STAFF REPORT
COMMUNITY DEVELOPMENT DEPARTMENT

HEARING DATE: September 19, 2024
 TO: Planning & Zoning Commission
 FROM: Sonya Allen, Associate Planner
 208-884-5533
 SUBJECT: Baldcypress Multi-family CUP
[H-2024-0028](#)
 LOCATION: 3570 N. Eagle Rd., in the SW 1/4 of
 Section 33, T.4N., R.1E. (Parcel:
 #R7991140012)

Conditional Use Permit for a multi-family development consisting of 115 residential units on 3.76-acres of land in the C-G zoning district.

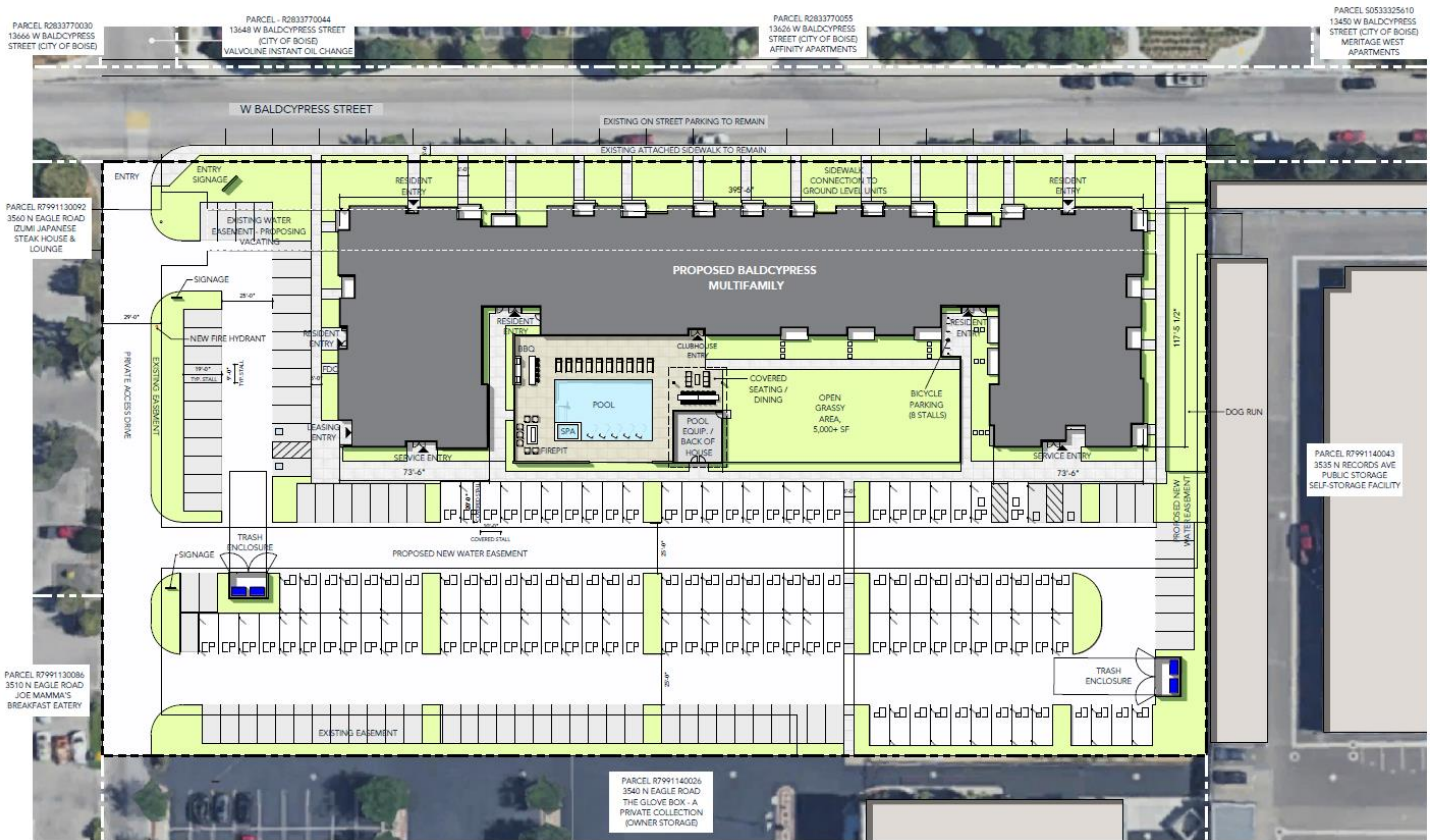
Existing Easements: There are existing easements that run along the northern, western and a portion of the southern boundary of the site as shown below; no structures should encroach and no trees should be planted within these easements.

The proposed structure encroaches in the easement along the north boundary; the Applicant plans to vacate this easement (ESMT-2007-0133 Smitchger Subdivision North). The vacation application

6. A vacation application shall be submitted to vacate the existing easement (ESMT-2007-0133 Smitchger Subdivision North) along the northern boundary of the site.

SP1 CONCEPT SITE PLAN

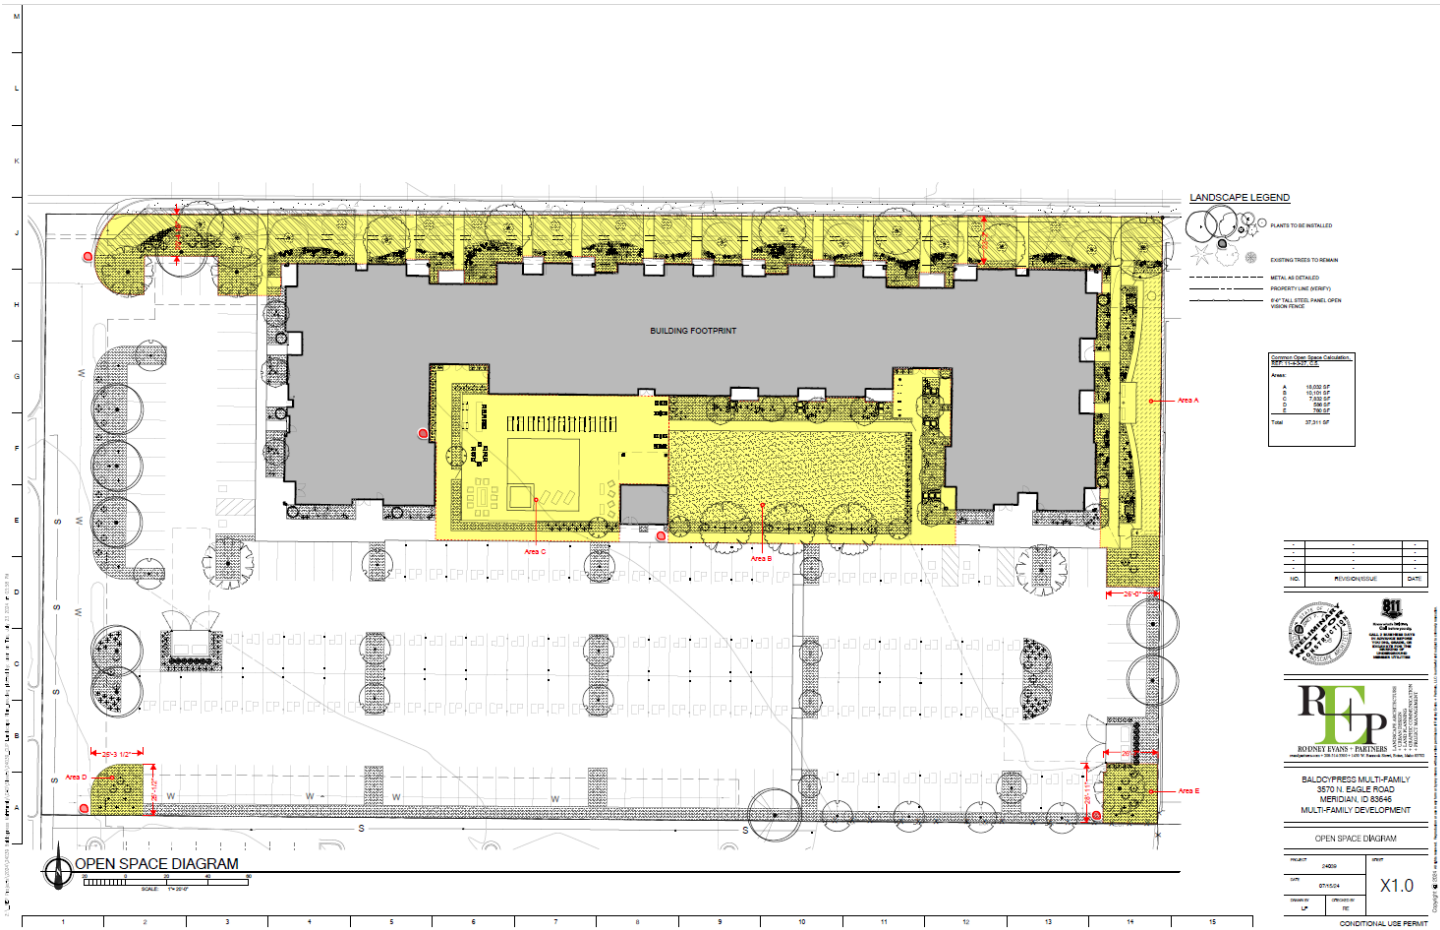
2. All on-site service areas, outdoor storage areas, waste storage, disposal facilities, and transformer and utility vaults shall be located in an area not visible from a public street or shall be fully screened from view from a public street. *The site plan depicts screened trash enclosures not visible from a public street; all proposed transformer/utility vaults and other service areas shall comply with this requirement.*

Per the application narrative, a total of 190 spaces are proposed with 115 of those covered as noted with "CP" on the site plan; the number of bicycle parking spaces are not specified. There are 20 additional on-street parallel parking spaces available along the south side of Baldcypress St. along the northern boundary of the site for overflow parking. The on-site parking meets and exceeds UDC standards by one (1) space; the additional on-street spaces will provide overflow parking if needed.

*Vehicle parking should comply with the required stall and drive aisle dimensions in UDC Table 11-3C-5; bicycle parking should comply with the standards in UDC 11-3C-5C. A bicycle rack(s) capable of holding at least eight (8) bicycles is required; a bike rack holding 8 bicycles is depicted on the site plan near the resident entry on the east end of the building. **A detail of the bicycle rack should be submitted that demonstrates compliance with the aforementioned standards.***

Parking lot landscaping is required in accord with the standards listed in UDC 11-3B-8C. **Due to an existing water easement along the western portion of the southern boundary of the site, no trees can be placed in that location; an alternative compliance application should be submitted to UDC 11-3B-8C.1b.**

Parking: Off-street parking is required in accord with the standards listed in UDC Table 11-3C-6 as discussed above in #B.6. **Per Fire code requirements, structures over 2-stories in height are required to have 26-foot wide drive aisles closest to the building; the plans should be revised accordingly.**

When a bumper overhangs onto a sidewalk or landscape area, the parking stall dimensions may be reduced 2' in length if 2' is added to the width of the sidewalk or landscaped area planted in groundcover, per UDC 11-3C-5B.4. Alternatively, wheel restraints may be provided to prevent vehicle overhang per UDC 11-3C-5B.3. **There is parking along the west and south sides of the building and along the southern and eastern perimeter boundaries of the site that don't what wheel restraints to prevent vehicle overhang – Staff recommends wheel restraints are provided or an additional 2' is added to the abutting sidewalk or perimeter buffer to accommodate vehicle overhang in accord with UDC standards.**

4. The site and/or landscape plan submitted with the Certificate of Zoning Compliance shall be revised as follows:
 - a. Depict the location of the maintenance storage area in accord with UDC 11-4-3-27B.7.

- e. Include a detail of the bicycle rack that demonstrates compliance with the required standards in UDC 11-3C-5C.
 - f. Internal drive aisles shall be widened to 26-feet around the building in accord with Fire code requirements.

- g. Wheel restraints shall be depicted in parking spaces that abut sidewalks or perimeter buffers; or, an additional 2-feet shall be added to the abutting sidewalks and perimeter buffers to accommodate vehicle overhang in accord with UDC 11-3C-5B.3-4.

- i. Depict dense landscaping in perimeter buffers along the west, south and east boundaries of the parking area in accord with the standards in UDC 11-3B-9C (trees aren't allowed within the water easement but shrubs should be allowed).

5. An alternative compliance application shall be submitted to UDC 11-3B-8C.1b, which requires trees to be planted in perimeter buffers in parking lots, for the area encumbered by the water main easement (ESMT-2017-0058 Model Home Furnishings) along the western portion of the southern boundary of the site.
